## SERVICE BULLETIN

Document No. 159-005-02, Rev 1 December 10, 2013

*Models Affected:* Bell 204B, 205A, 205A-1, 212, 412, 412EP, Garlick UH-1H, and Agusta AB412

Subject: Cargo Hook enhanced safety.

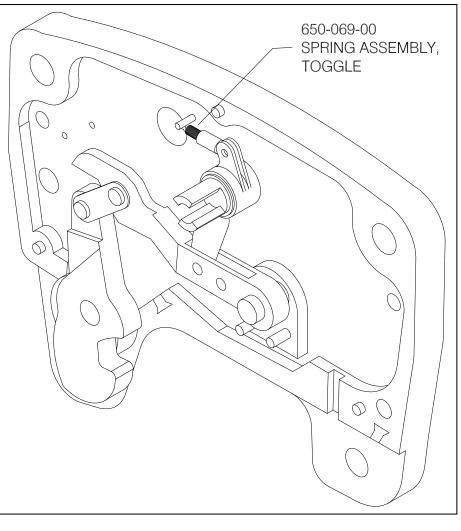
- 4. Remove P/N 650-066-00 or 650-041-00 Spring, Toggle and replace with P/N 650-069-00 Spring Assembly, Toggle. Do not remove the plastic cover from spring. Refer to Figure 1 for correct orientation of spring installation. End of spring with plastic cover can be pushed over roll pin in toggle assembly without removing roll pin and then hook the opposite end of spring over pin in case.
